**Additional Questions and Ideas Related to the 3rd Street Bridge/Dam Design  
Compiled by Friends of Glen Providence Park  
August 9, 2011**

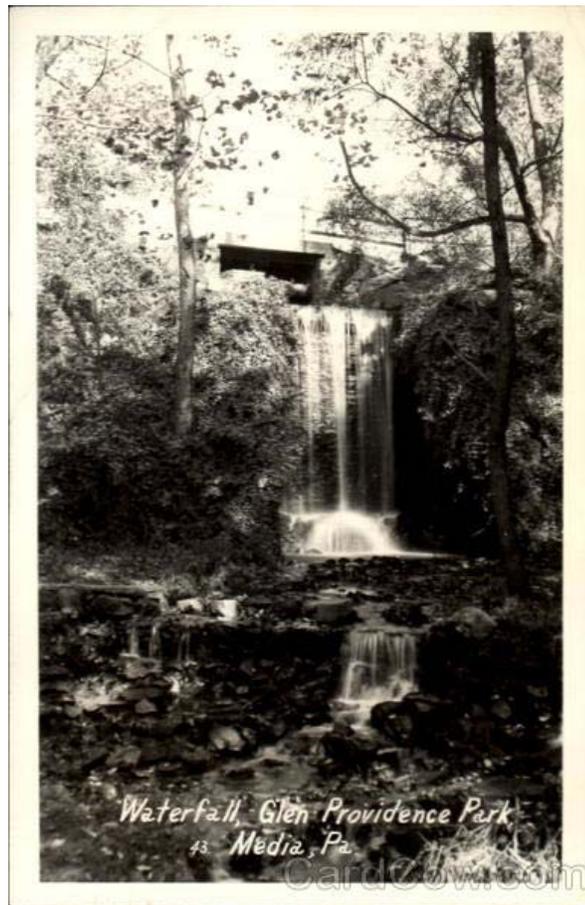
2. Can you put separate flags/markers in the ground showing the limits of the construction area? Is that synonymous with the "area of disturbance"?

*SE: Borough Council will investigate installation of markers to approximate the area of disturbance.*
